C/R Zone Development Standards

Re: Draft Bethesda Downtown Plan Design Guidelines

Re: Bethesda Design Guidelines

Sidewalk Zones

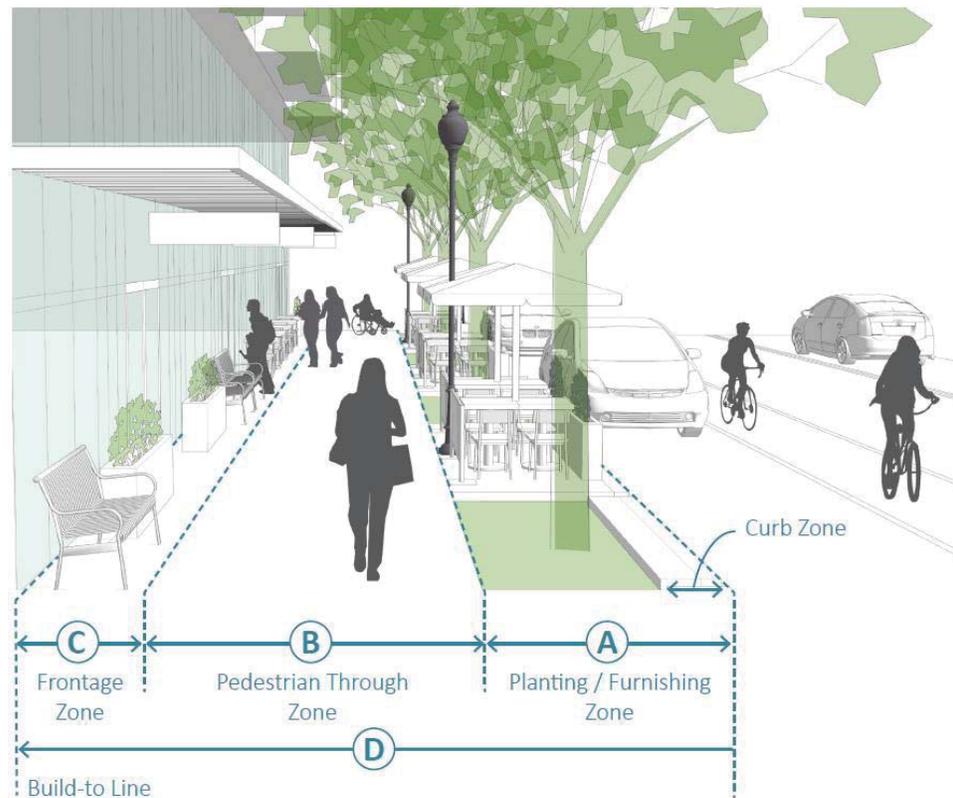
"In A: add to list of items to be accommodated in the buffer: signs, newspaper boxes, trash receptacles, signal boxes, bike racks" "

"In C: add to list of items to be accommodated in this zone, "opening of store doors". Add to final sentence about Pedestrian Through Zone: "provided any uses occurring in the Frontage Zone do not encroach into the Pedestrian Through Zone".

No sidewalk zone should be prioritized at the expense of the other zones; i.e. - the planting zone should not be reduced for a greater sidewalk width or vice versa.

`Pedestrian Through Zone: Provides adequate space between the Planting/Furnishing Zone and the Frontage Zone to allow for safe, comfortable, and unobstructed passage for people of all abilities. There should be no encroachments into this Zone from the other two zones."

Building Form

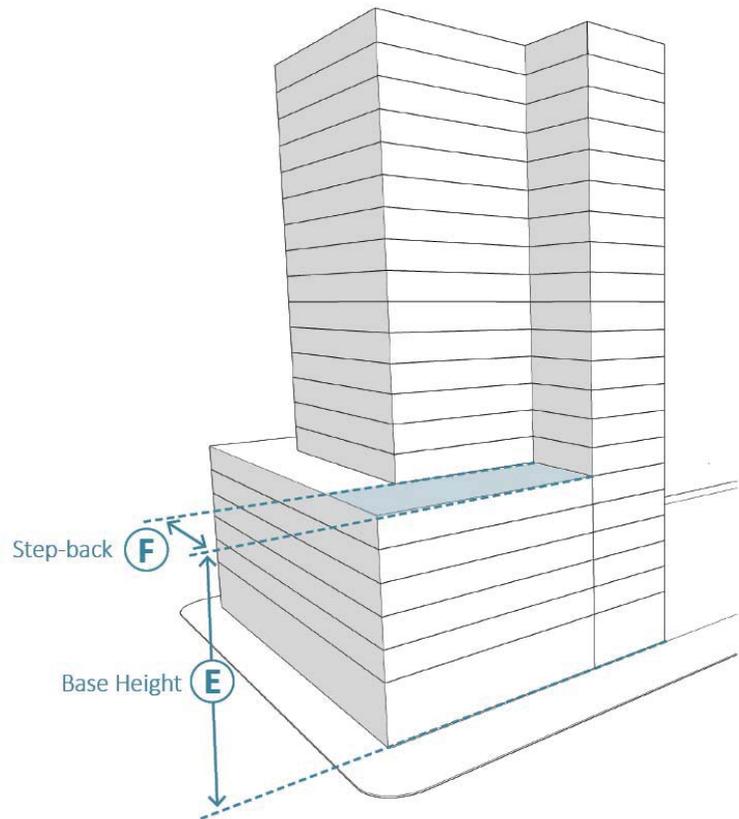
"Guidelines by Street Type" should be specific to street types and with it define the minimum dimension below. Dimensions could vary depending on the street type.

There need to be some definitive standards for bases and stepbacks.

Design Guidelines to Enhance the Capital Crescent Trail

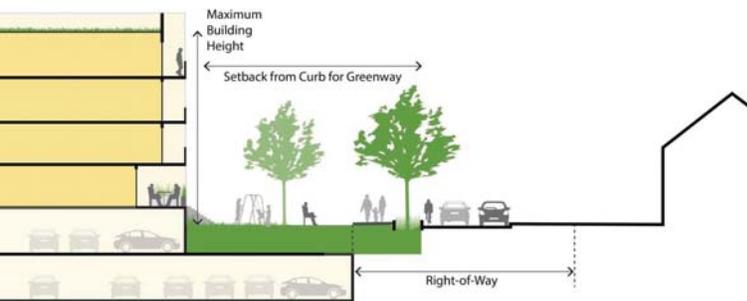
Provide sufficient transition space between activating uses on the property and the CCT to ensure safety for those off and on the CCT.

Tower: Separation Distance

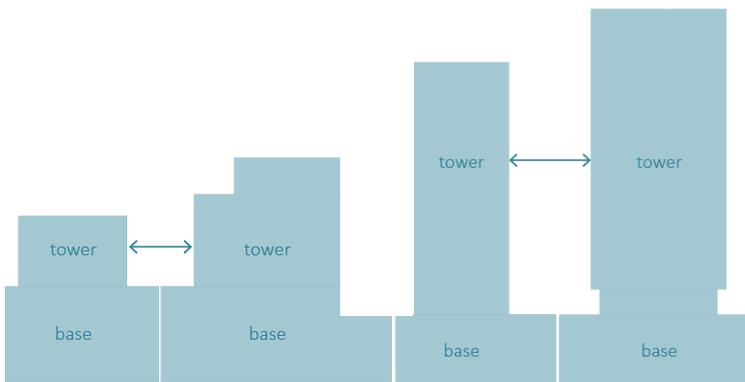
Need to define minimum separations.

Add specific requirements for building separation, step backs, and desirable mid-block connections. on).

Tower: Step-Back

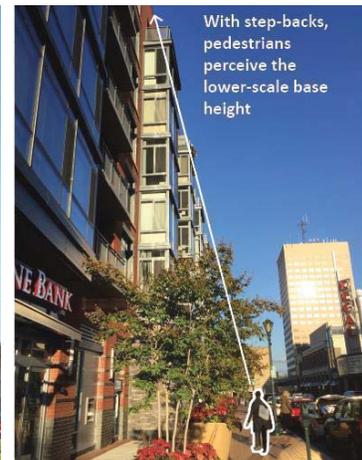
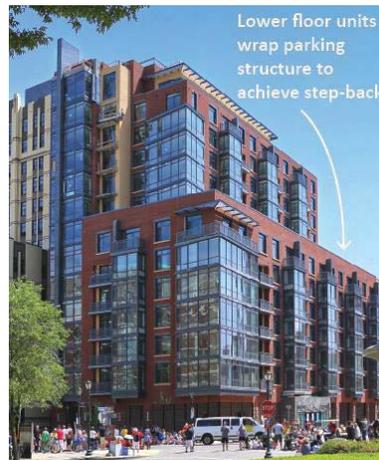
Also, would the wind effect item go here with the other tall tower items? They did refer to making those buildings nice for pedestrians and wind sure isn't.

“Tower placement. Towers rising above the base should be setback from the base or podium to minimize the visual and physical impact on the adjacent residential neighborhoods, parks, open space, and historic buildings, as well as allow the base building to be the primary defining element for the site and adjacent public realm.

“Buildings step down toward residential neighborhoods. Tall buildings located on properties that abut either Greenway properties or properties subject to the Compatibility Requirements should step down towards the residential properties so as to transition sensitively to the residential neighborhoods.”
